## **2.5 Geology, Seismology, and Geotechnical Engineering**

PSEG Site early site permit (ESP) application, Section 2.5, "Geology, Seismology, and Geotechnical Information," of the Site Safety Analysis Report (SSAR), Revision 3, contains information on geologic, seismic, and geotechnical characteristics of the proposed ESP Site. The applicant (PSEG) followed guidance in Regulatory Guide (RG) 1.208, "A Performance Based Approach to Define Site-Specific Earthquake Ground Motion," to define the following four zones around the site and conducted investigations in those zones that became progressively more detailed passing from site region to site location:

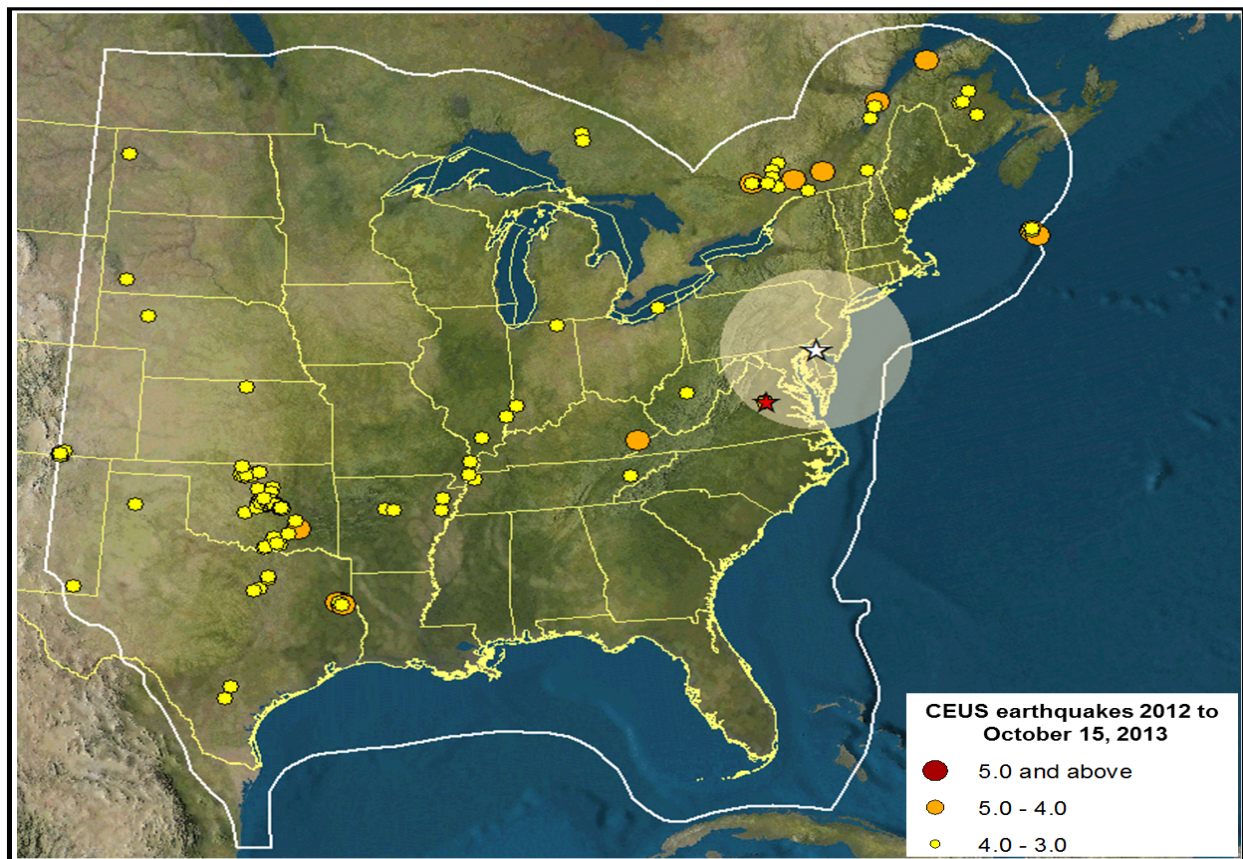
window covering 2009 through October 15, 2013, throughout the CEUS as defined by NUREG-2115. The staff's supplementary earthquake catalog confirmed that the applicant adequately updated its catalog from 2009 through 2011. In addition, the staff's catalog showed that there are 173 earthquakes in the CEUS region (Figure 2.5.2-6 of this report) that occurred between 2012 and October 15, 2013. None of these earthquakes have moment magnitudes (**M**) equal to or greater than **M5.0**. The staff identified 15 earthquakes in the range between **M4.0** and 4.9 distributed over the CEUS region. The majority of the earthquakes (158 of the 173) in the updated catalog are small magnitude earthquakes (**M** < 4.0). Therefore, the staff concludes from its confirmatory analysis that the earthquakes in the staff's supplementary catalog are located within identified active CEUS seismic regions and do not add any new information to the catalog used by the applicant.

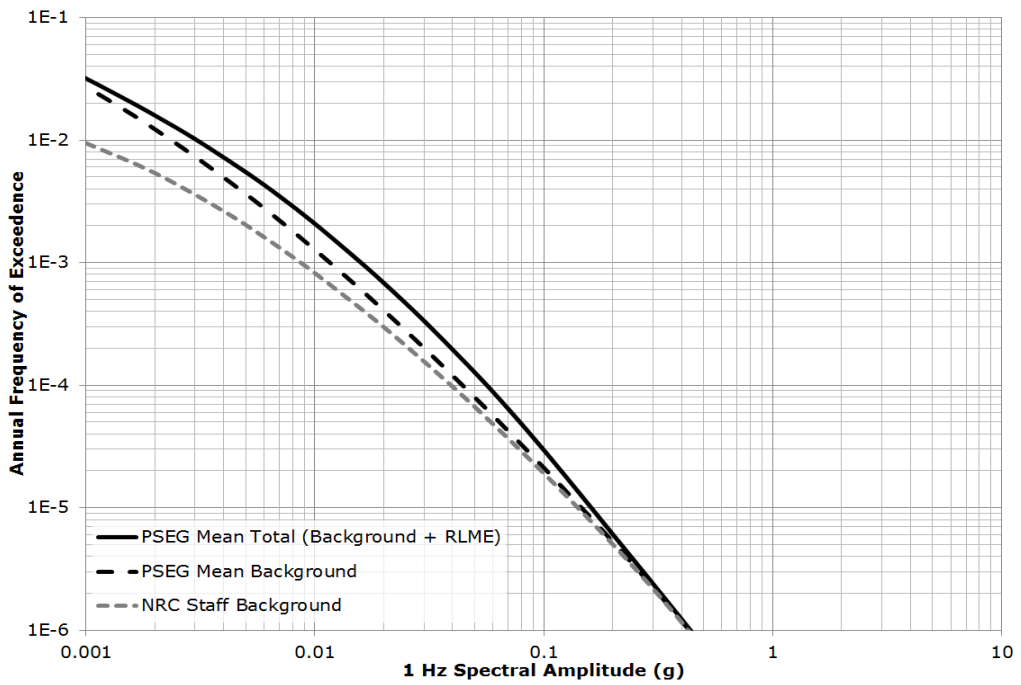
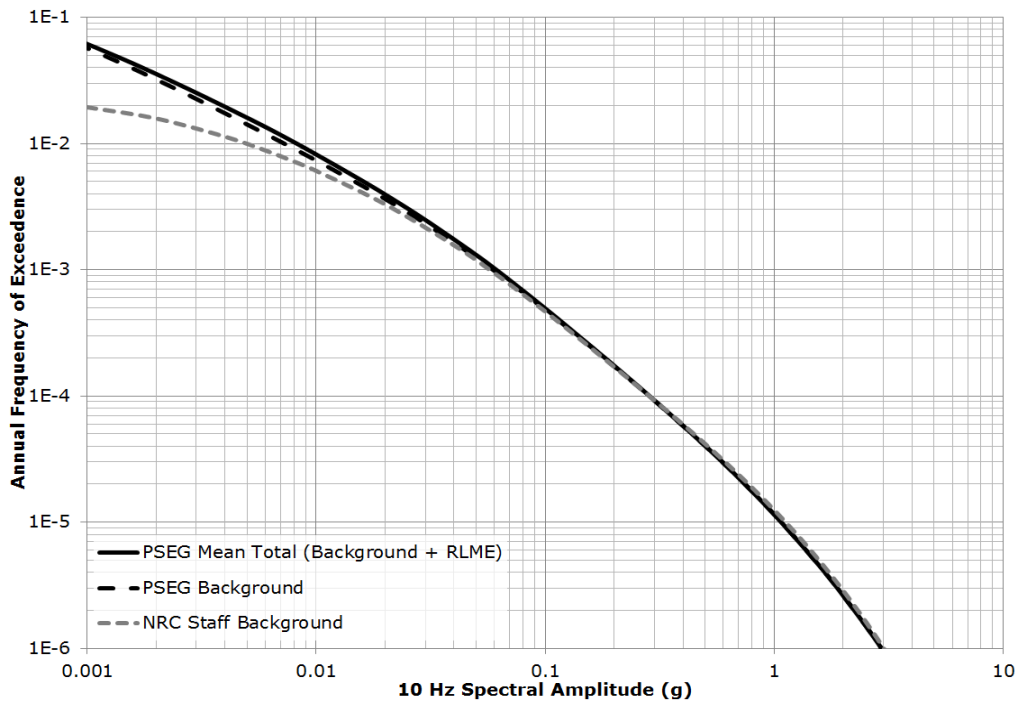
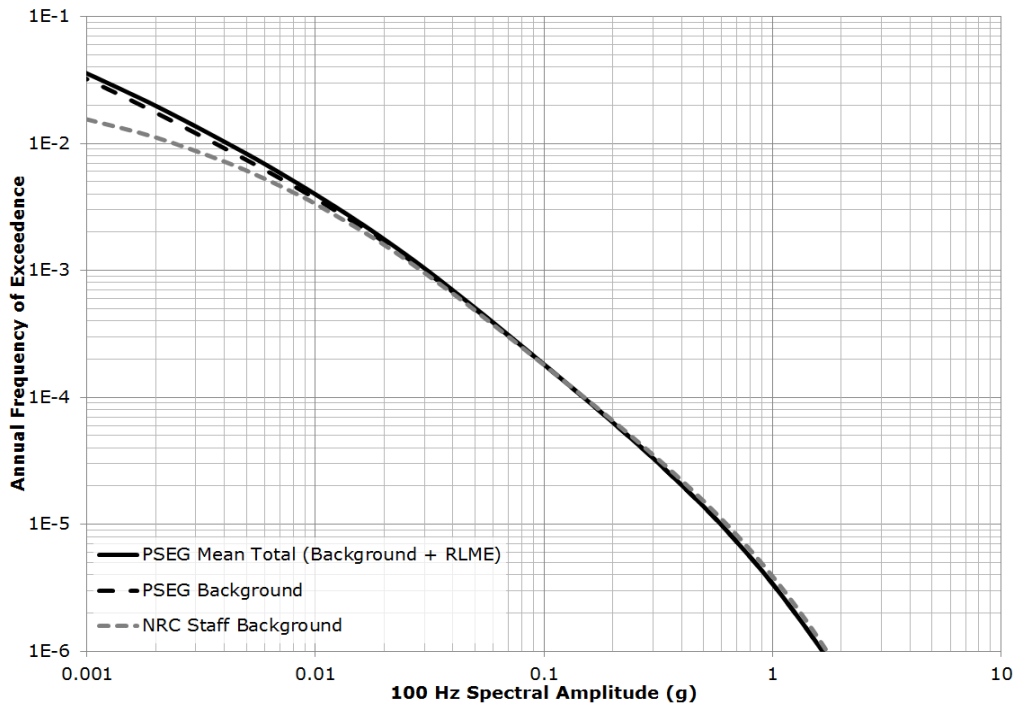
As part of its confirmatory analysis, the staff used the NUREG-2115 CEUS-SSC model background (distributed seismicity) sources and independently calculated the seismic hazard curves at the PSEG Site for all seven ground motion frequencies defined in the EPRI (2004, 2006) ground motion prediction models. The staff's confirmatory calculations did not include the RLME sources. These sources exist at distances beyond 800 km (500 mi) from the PSEG Site and are expected to contribute only at low frequencies such as 0.5 and 1 Hz. From the NUREG-2115 seismic source model, the staff first selected all background seismic sources that are within the 320 km (200 mi) site region. For those seismic sources which are partly within the 320 km (200 mi) site region, but with boundaries extending beyond the site region, the staff used a distance cut off of 500 km (312 mi). Beyond that distance, their hazard contributions will be negligible. Figure 2.5.2-7 of this report shows the staff's results as compared to the applicant's for PGA and ground motion frequencies of 10 and 1 Hz. The staff's confirmatory calculations show that for the annual frequency of exceedances of  $10^{-4}$ ,  $10^{-5}$ , and  $10^{-6}$ , the staff's seismic hazard curves are in good agreement with the applicant's background seismic hazard curves. The difference observed between the background seismic source hazard curves and the total seismic hazard curve at 1Hz shown in Figure 2.5.2-7 of this report is attributed to the contribution of the RLME seismic sources at large distances. As shown in SSAR Figures 2.5.2-25 through 2.5.2-30, at low frequencies, such as 2.5, 1, and 0.5 Hz, distant RLME sources contribute to the hazard at the site. In contrast, at high frequencies only local sources contribute to the hazard. Based on this analysis, the staff concludes the applicant adequately characterized the mean seismic hazard at the PSEG Site.

**Figure 2.5.2-8 Comparisons of the staff's site response amplification function with the amplification function determined by the PSEG applicant for the 10-5 annual frequency of exceedance**

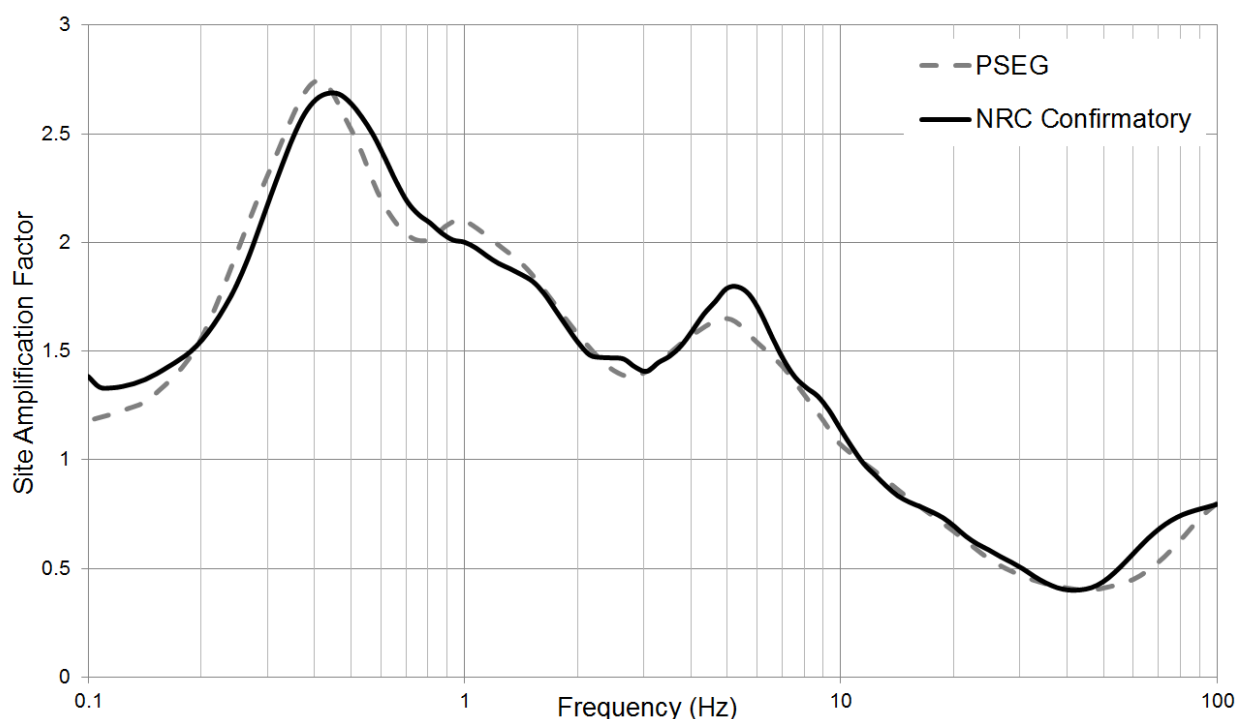
To determine the adequacy of the applicant's site response calculations, the staff performed its own confirmatory site response calculations. As input, the staff used the static and dynamic soil properties provided in SSAR Section 2.5.4. To represent the input rock motions, the staff used the applicant's low- and high-frequency  $10^{-5}$  rock spectra. The staff performed its site response calculations using the Strata software (Kottke and Rathje 2008). The staff's site amplification function results are compared with the applicant's results in Figure 2.5.2-8 of this report, which shows that the staff's calculation is similar to the applicant's site amplification factor across the frequency range typically important for engineering purposes (i.e., 0.5 to 10 Hz) and they are within the limits of uncertainties expected from these calculations. Based on this assessment, the staff concludes that the applicant's site response calculations adequately characterize the site effects at the PSEG Site.
